LEGACY CHURCH FAÇADE JSP 15-66

Approval at the request of Connecting Spaces LLC for Preliminary Site Plan and Section 9 Façade Waiver. The subject property is located in Section 22, South of Eleven Mile Road and east of Taft Road, in the R-4, One Family Residential zone. The subject property is approximately 6.25 acres and the applicant is proposing to remodel the existing façade for Legacy Church along with modifications to the existing parking lot, internal sidewalks and remodel the interior of the school building.

PLANNING REVIEW

Legacy Church – Façade Change, minor site improvements
JSP 15-66

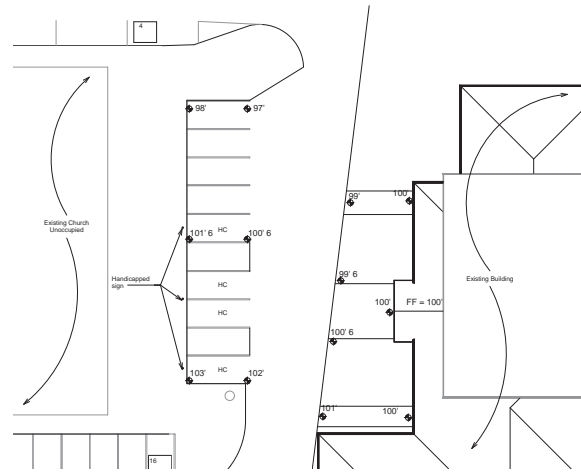
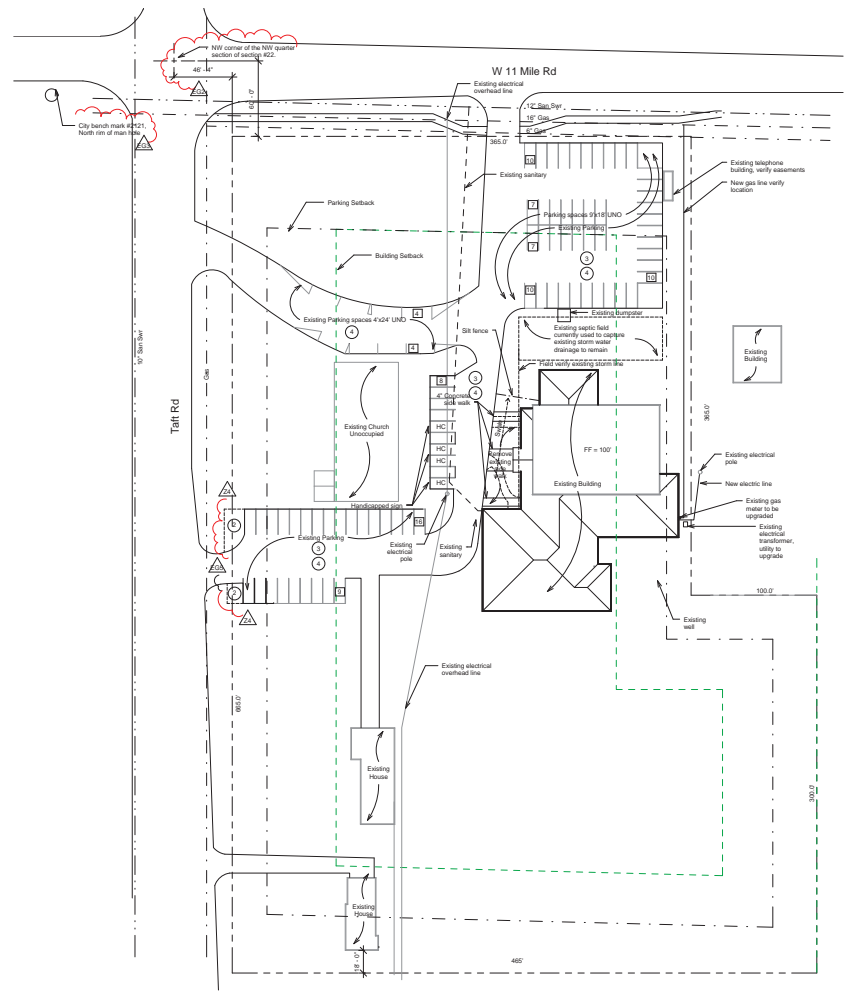
E1. Provide calculations and details showing that the, proposed septic field/storm detention meets the City of Novi underground detention and infiltration standards detailed in the Engineering Design Manual.

E2. Clarify how storm water will be conveyed to septic field/storm detention. Additional Comments lto be addressed prior to the Final Site Plan submittal):

EG1. Provide a note on the plans that all work shall conform to the current City of Novi standards and specifications.

EG2. Provide a minimum of two ties to established section or quarter section corners.

EG3. Revise the plan set to reference at least one city established benchmark. An interactive map of the City's established survey benchmarks can be found under the IMap Gallery' tab on www.cityofnovi.org.

EG6. Provide a note stating the size of the disturbed area.

EG7. Provide a traffic control sign table listing the quantities of each sign type proposed for the development. Provide a note along with the table stating all traffic signage will comply with the current MMUTCD standards.

Impervious area will be reduced with proposed development. We have shown a table on the lower right area of sheet C101.

The property is served by the city sanitary sewer system. When the switch to the sanitary system took place the roof storm drainage was piped into the old septic field. No additional parking to be added.

No change to current system is proposed. We have reworded the notes sheet C101.

A note stating such has been added to “Site Notes” on the upper left corner of sheet C101.

The quarter section is at the center of Taft Road and W. 11 Mile Road (northwest corner of the current property). The ties are added to the site plan on sheet C101.

The city benchmark #2121 is near the southwest corner of the intersection of Taft Road and W. 11 Mile Road and is identified on the site plan on sheet C101.

Provided in the “Site Data” in upper left corner of sheet C101.

The only new signage is four handicapped parking signs. See detail on left side of sheet C101.
